Subject: Permit Modification Request for the Waste Isolation Pilot Plant Hazardous Waste Facility Permit, Number NM4890139088-TSDF

- Clarification of TRU Mixed Waste Disposal Volume Reporting

**Class 2 Permit Modification Request**  
**Clarification of TRU Mixed Waste Disposal Volume Reporting**  
**Waste Isolation Pilot Plant**  
**Carlsbad, New Mexico**  
**WIPP Permit Number - NM4890139088-TSDF**

**January 2018**

**Table J-3  
Underground Hazardous Waste Disposal Units**

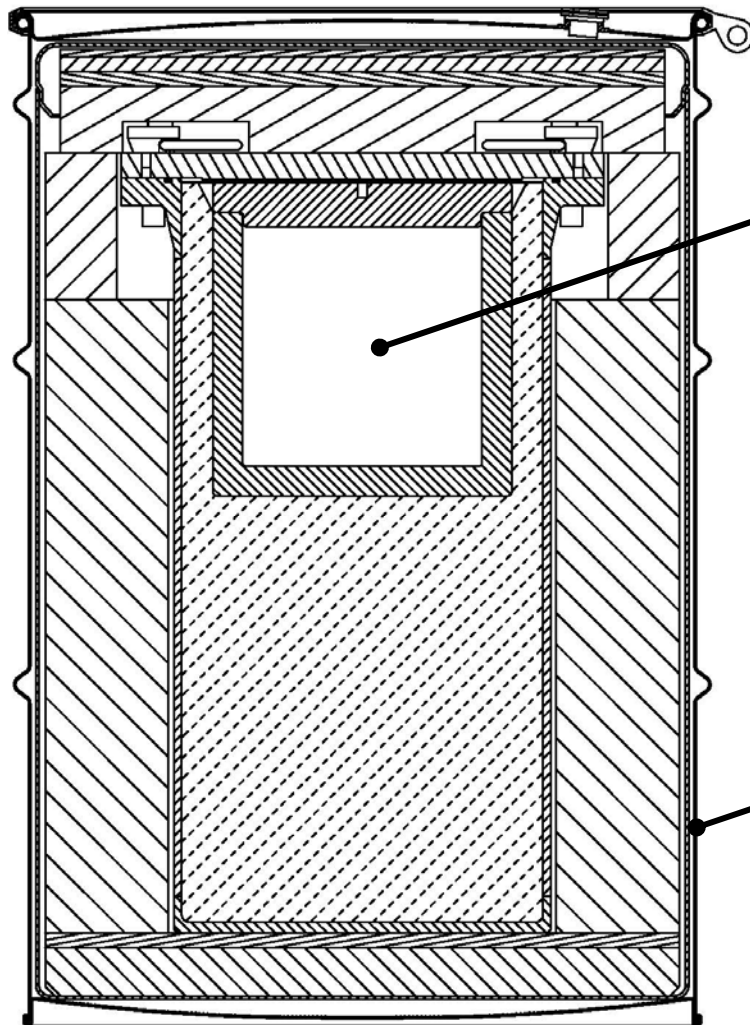
- Revise Attachment J, Table J-3, *Underground Hazardous Waste Disposal Units*, to delete the reference to the WIPP LWA total capacity limit of 6.2 million ft<sup>3</sup>.

Description <sup>1</sup>	Waste Type	Maximum Capacity <sup>2</sup>	Container Equivalent
Panel 1	CH TRU	636,000ft <sup>3</sup> (18,000 m <sup>3</sup> )	86,500 55-Gallon Drums
Panel 2	CH TRU	636,000 ft <sup>3</sup> (18,000 m <sup>3</sup> )	86,500 55-Gallon Drums
Panel 3	CH TRU	662,150 ft <sup>3</sup> (18,750 m <sup>3</sup> )	90,150 55-Gallon Drums
Panel 4	CH TRU	662,150 ft <sup>3</sup> (18,750 m <sup>3</sup> )	90,150 55-Gallon Drums
	RH TRU	12,570 ft <sup>3</sup> (356 m <sup>3</sup> )	400 RH TRU Canisters
Panel 5	CH TRU	662,150 ft <sup>3</sup> (18,750 m <sup>3</sup> )	90,150 55-Gallon Drums
	RH TRU	15,720 ft <sup>3</sup> (445 m <sup>3</sup> )	500 RH TRU Canisters
Panel 6	CH TRU	662,150 ft <sup>3</sup> (18,750 m <sup>3</sup> )	90,150 55-Gallon Drums
	RH TRU	18,860 ft <sup>3</sup> (534 m <sup>3</sup> )	600 RH TRU Canisters
Panel 7	CH TRU	662,150 ft <sup>3</sup> (18,750 m <sup>3</sup> )	90,150 55-Gallon Drums

RH TRU	22,950 ft <sup>3</sup> (650 m <sup>3</sup> )	730 RH TRU Canisters
Panel 8	CH TRU	662,150 ft <sup>3</sup> (18,750 m <sup>3</sup> )	90,150 55-Gallon Drums
	RH TRU	22,950 ft <sup>3</sup> (650 m <sup>3</sup> )	730 RH TRU Canisters
<b>Total</b>	<b>CH TRU</b>	<b>5,244,900 ft<sup>3</sup></b> <b>(148,500 m<sup>3</sup>)</b>	<b>713,900 55-Gallon Drums</b>
	<b>RH TRU</b>	<b>93,050 ft<sup>3</sup></b> <b>(2,635 m<sup>3</sup>)</b>	<b>2960 RH TRU Canisters</b>
